SAMPLE DRAWINGS

SUBMITTAL 1

PROJECT:
SAMPLE DRAWINGS

APPROVAL DATE	-
PLOT DATE	07/11/2024
PROJECT NUMBER	P-5567446
ROOM NAME	GENERAL INFO.
SHEET NUMBER	1CS.01

02 BREAK ROOM A204
ELEVATION
SCALE: 3/4"=1'-0" ARCH REF.: A2/A608

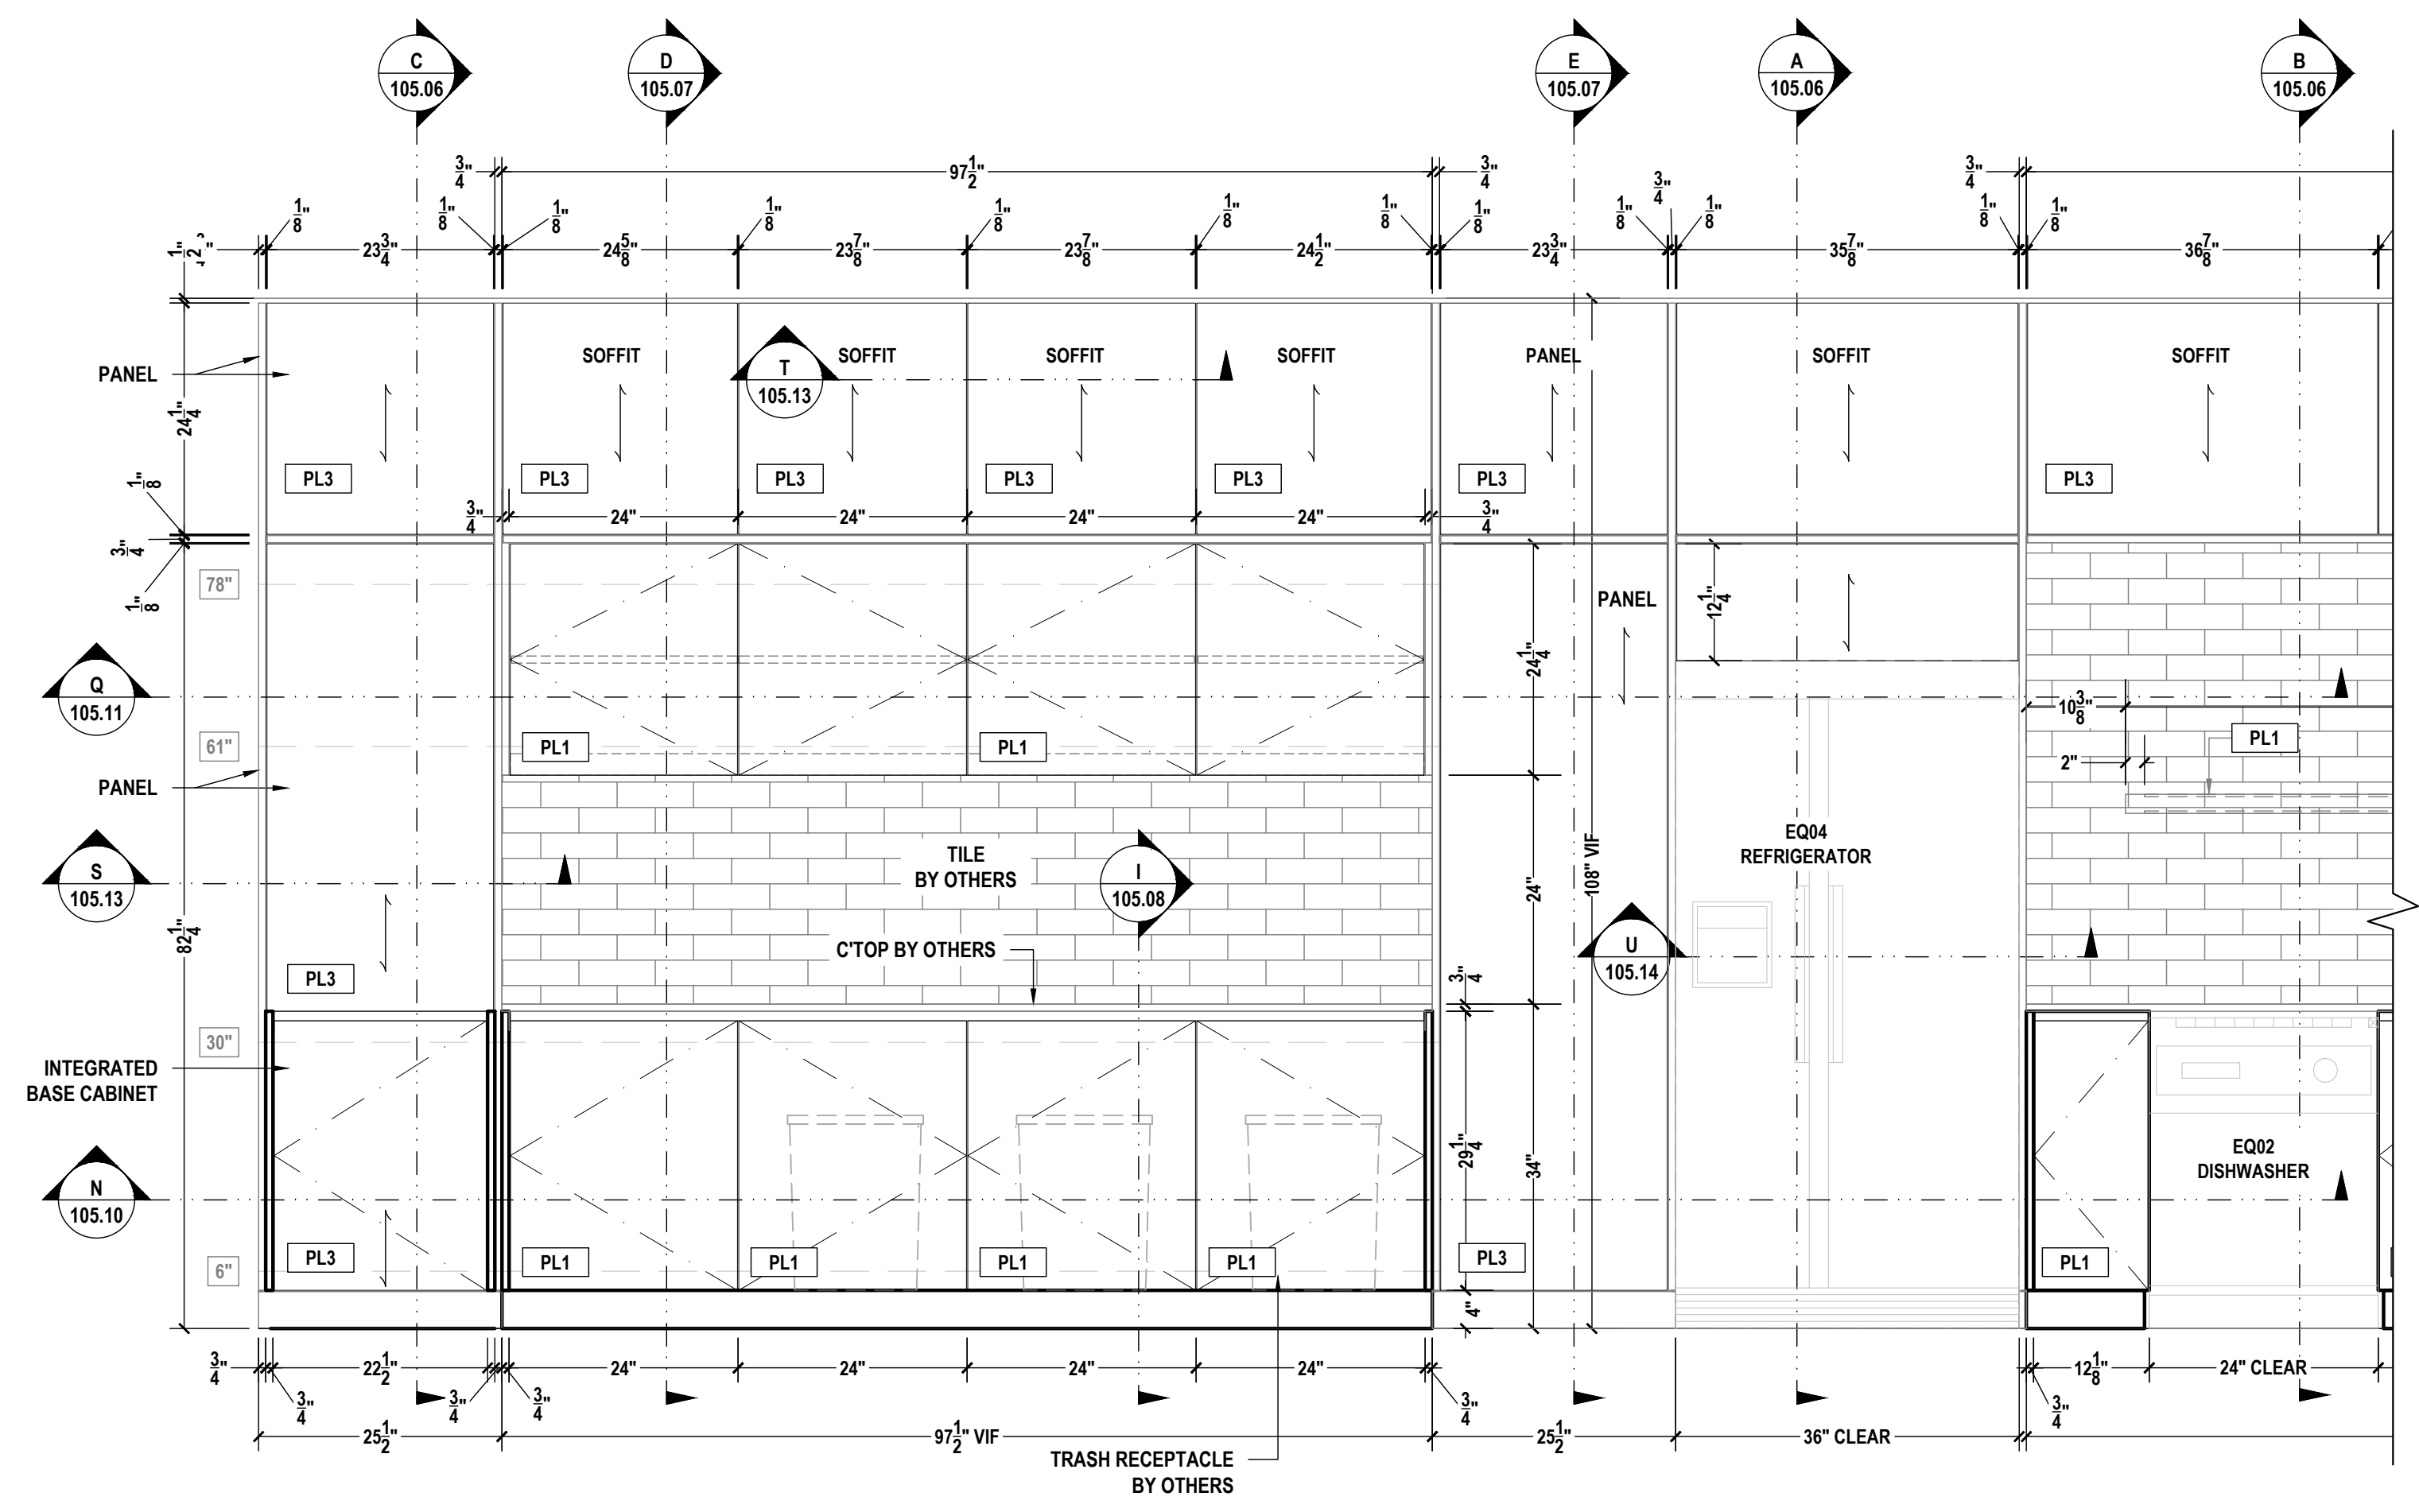
**** NOTE TO ARCH AND G.C. ****
REFERENCE RFI LIST ON SHEET 1CS.02

PLEASE PROVIDE P-2 AND P-2X SPECIFICATIONS.

RFI'S / CLARIFICATION				
NO.	TMS REF.	ARCH REF.	QUESTION	G.C. / ARCHITECTS COMMENTS
01	03/105.03	A2/A608	PLEASE PROVIDE P-2 AND P-2X SPECIFICATIONS	IN THE APPROVED ADDENDUM G.C. WILL PROVIDE SPECS.
02	02/105.02	A2/A608	PLEASE PROVIDE EQUIPMENT SPECIFICATIONS.	USE THE SAME EQUIPMENT SPECS OF THE WORKING ROOM A108
03	03/102.02	A11/A605	PLEASE PROVIDE WD2 SPECIFICATIONS	WHITE OAK. PROFILE T3T8 RUBIO MONOCOAR
04	09/105.05	A8/A608	PLEASE PROVIDE EQ05, EQ06 AND EQ07 SPECIFICATIONS.	IN THE APPROVED ADDENDUM G.C. WILL PROVIDE SPECS.
05	PAGE#	PAGE#	QUESTION	COMMENT
06	PAGE#	PAGE#	QUESTION	COMMENT
07	PAGE#	PAGE#	QUESTION	COMMENT
08	PAGE#	PAGE#	QUESTION	COMMENT
09	PAGE#	PAGE#	QUESTION	COMMENT
10	PAGE#	PAGE#	QUESTION	COMMENT

08 BREAK ROOM A204
ELEVATION
SCALE: 3/4"=1'-0" ARCH REF.: A5/A608

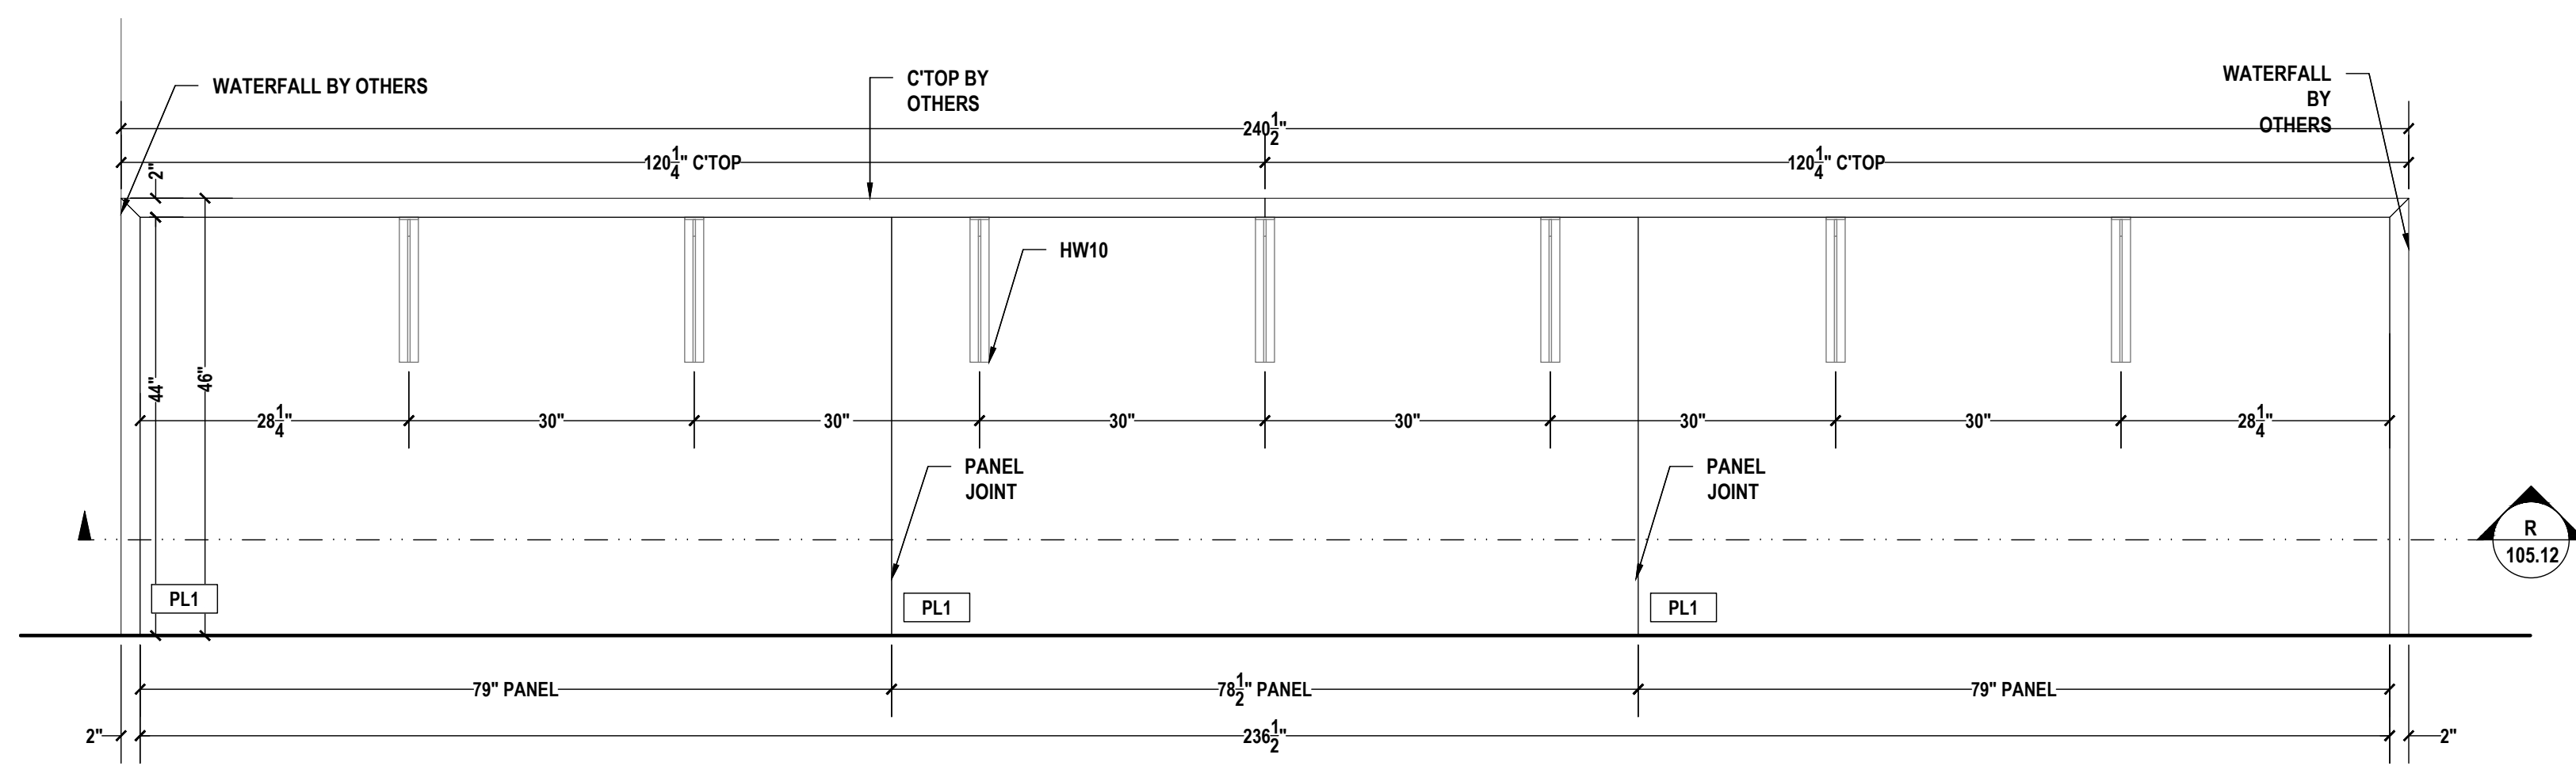
**** NOTE TO ARCH AND G.C. ****
REFERENCE RFI LIST ON SHEET 1CS.02
PLEASE PROVIDE EQ05, EQ06 AND EQ07 SPECIFICATIONS.
